PREPARED FOR THE URBAN DESIGN COMMISSION

**Project Address:** Bus Rapid Transit (BRT) Station Design Competition  
**Application Type:** Final Approval is Requested  
**Legistar File ID #** [65580](#)  
**Prepared By:** Janine Glaeser, UDC Secretary

# Station Design Competition

## East-West Bus Rapid Transit

## 2140

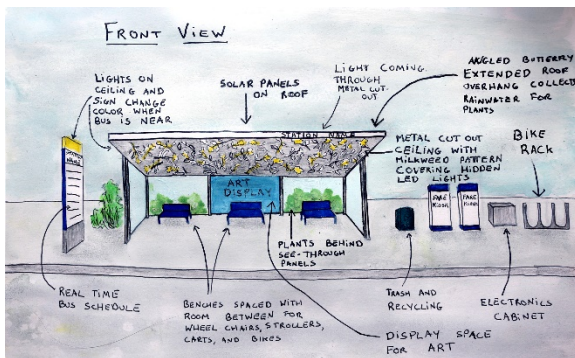
- Very busy – a lot going on.
- Will be hard to keep clean and maintained (broken/ clean glass, chairs, people sleeping, etc.)
- No bicycle features
- Seems very tall
- Obstruct views
- Green roofs are higher maintenance than other roof systems.

- Overall height, clerestory, green roof could challenge budget, but solvable.
- Cantilever roof excessive, but column(s) would not damage concept.
- Constructible if the columns are added to support the green roof ends.

## 4851

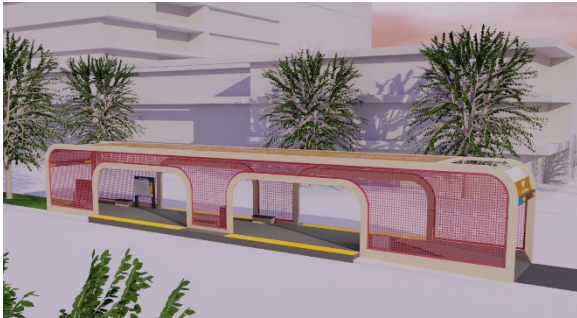
- The use of sandstone
- Plain, not many unique features
- Lacking amenities
- White/ light colors
- Does not appropriately leave room for all doors of the bus

- Need larger size of structural members, but plausible.
- May need gutters, downspouts and connection to storm drain

## 4915

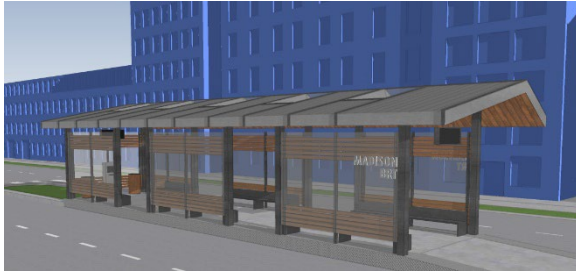
- Too retro, colors are flashy
- Doesn't look like Madison or midwest
- Design would not work well in cold weather.
- Not a great fit for historic context

- Needs additional vertical structure along length & interconnecting outside arch to inside arch
- Needs internal gutters & downspouts tied to storm drains
- Mesh material needs to be durable and sustainable

## 7014

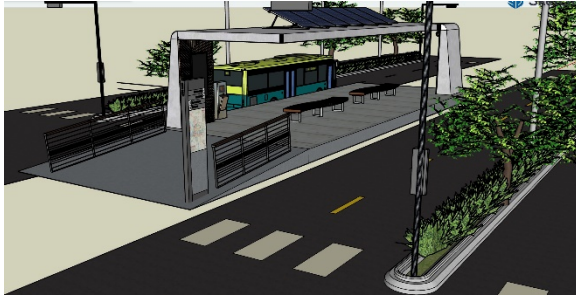
- Design is cliché
- Doesn't fit UW branding
- Not a great fit for historic context
- Not enough seating
- Little protection from weather
- Not scalable
- Wood finishes are more expensive to maintain

- Needs gutters, downspouts and storm drain connections.

## 8472

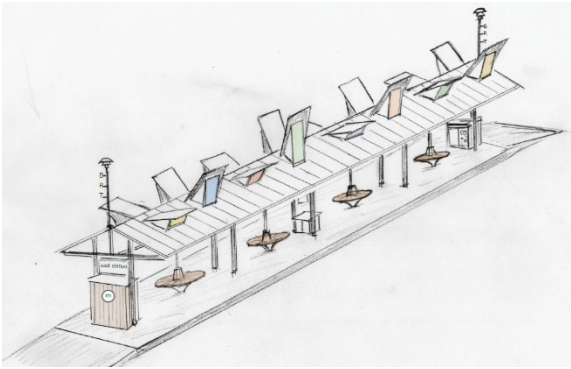
- Too unique
- Lacks any shelter
- Looks like a subway entrance, not BRT
- Dangerous - encourages people to climb up the roof
- Low ceiling clearance on one end
- Wood finish may have a higher maintenance cost than other finishes.

- Relationship of glulam to vertical support in 'w\_Raingarden' picture confusing - meant to shed water from concave shape to sidewalk?
- Depending on highway transport regulations, could be prefab off-site and transported.
- Patron level screenings would need to be sustainable and durable.
- Need downspouts and connections to storm drain.
